**Re: Tyrone Mine Permit GR010RE, Tyrone Mine
Emma Expansion Application Response Letter**

Freeport-McMoRan Tyrone Inc. (Tyrone) submitted an application for an expansion to the Tyrone Mine for the Emma Project on October 22, 2021 and Closure/Closeout Plan (CCP) on November 12, 2021. In a letter dated April 8, 2022, Mining and Minerals Division (MMD) provided comments. This letter is in response to MMD's comments.

LAND DIVISION SURVEY OF PROPERTY OF LT RANCH, LLC. - WITHIN THE S₂ OF SECTION 25, THE W_{1/2} OF SECTION 36, AND THE E_{1/2} & NE_{1/4}W_{1/2} OF SECTION 35, T19S, R15W, N.M.P.M., GRANT COUNTY, NEW MEXICO

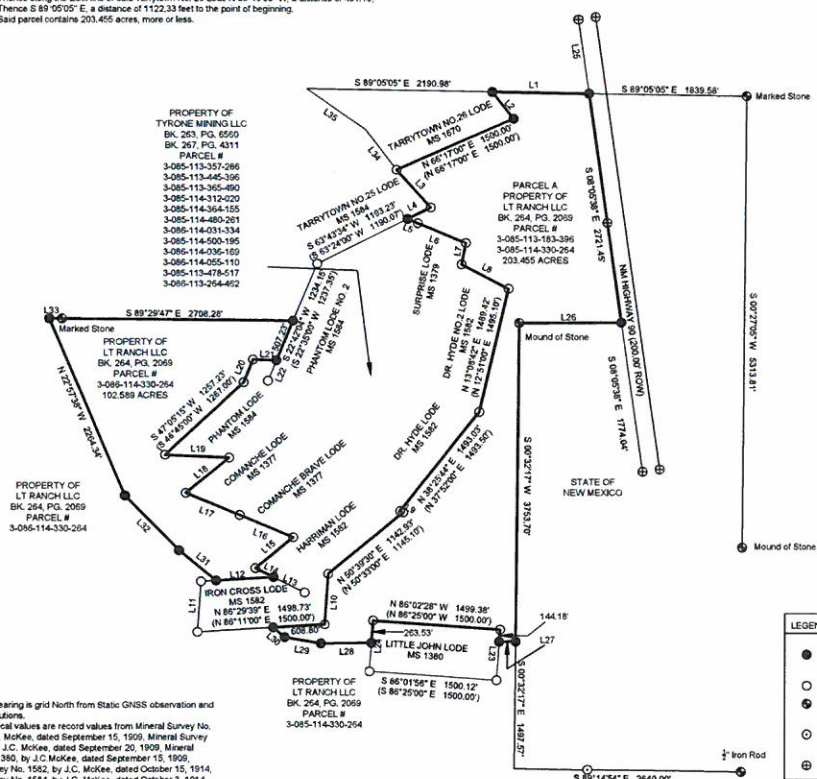
1. *Tyrone Response to requirements of 19.10.5.502.D(2) NMAC, Attachment 1, page 2 of 5, and Figure 1, Owners of Surface and Mineral Estates within the Proposed Emma Area. Tyrone notes that a certain portion of the Emma Project surface area is owned by the LT Ranch LLC and is currently under contract of sale to Tyrone, as shown in Figure 1 (Owners of Surface and Mineral Estates Within the Emma Area). Please inform MMD as soon as Tyrone is the surface landowner of this property.*

Tyrone purchased the LT Ranch LLC area on December 17, 2021. Attached is the Land Division Survey of Property of LT Ranch LLC. that Tyrone purchased.
